**1. Project Name:** [Marriott Hotel at Cesar Chavez](#)

Marriott Hotel at Cesar Chavez

Date: May 17, 2017  
To: Austin Design Commission  
From: Planning & Urban Design Working Group  
Subject: Working Group Density Bonus Program review of "The Marriott Hotel at Cesar Chavez" for substantial compliance with the Urban Design Guidelines.  
Meeting Date: May 12, 2017; 12:00 pm  
Applicant: Richard T. Suttle, Jr.- Armbrust & Brown, PLLC  
Architect: HKS

### DESIGN COMMISSION WORKING GROUP COMMENTS REGARDING PROJECT'S COMPLIANCE WITH URBAN DESIGN GUIDELINES

EAST ELEVATION

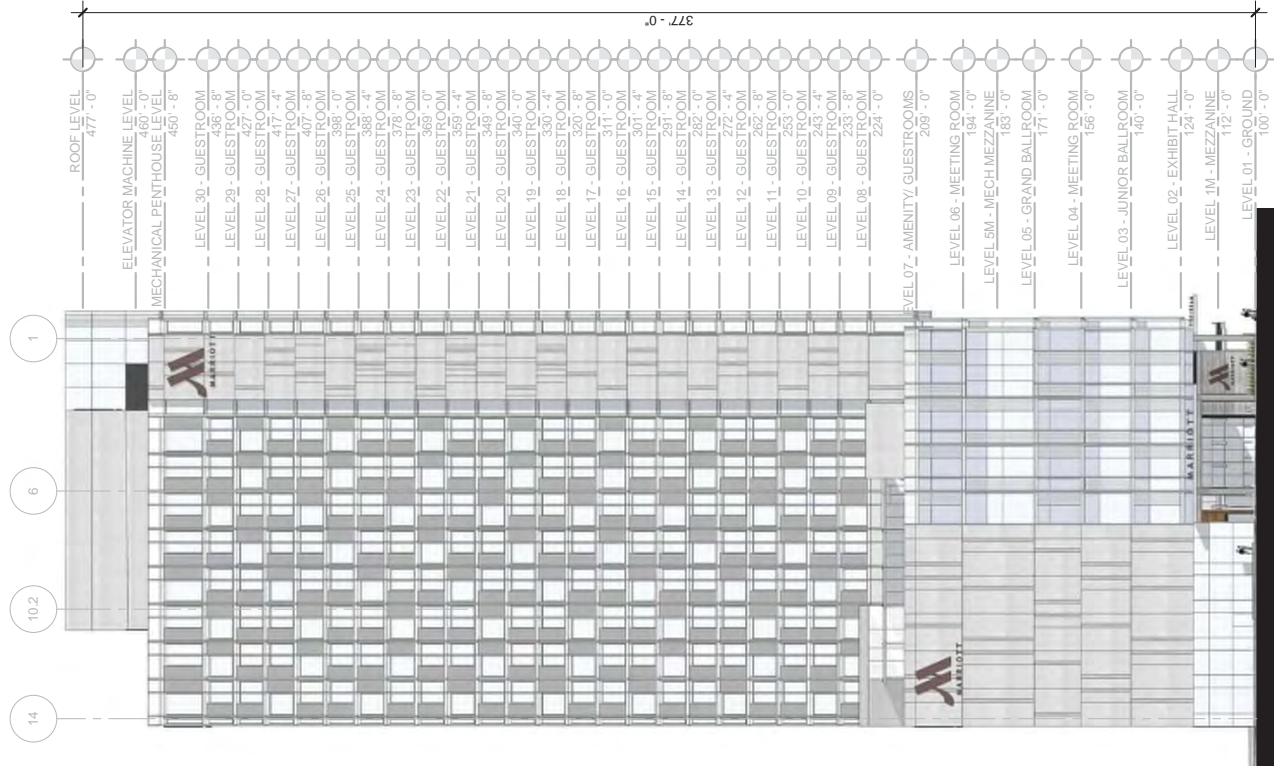
- Building encroachment into ROW on east about 8' into 20' walk. Concerns about view corridor in street and overhang impacts on street trees.
- Non-active east façade at level 1, 2. Applicant proposes using glass for a more interesting material, not solid wall/door material.
- Non-active façade to west at stairs at level 1. Applicant proposes using glass for stair walls/doors and implementing a branded elevator to provide access to public space at the roof.
- Visibility is limited for vehicle exit onto alley. This could be a safety issue.
- Amount of vehicle space at south west corner at ground level is not pedestrian friendly, so it is important to have the food trailer shown, or notch out corner for a tree and green space.
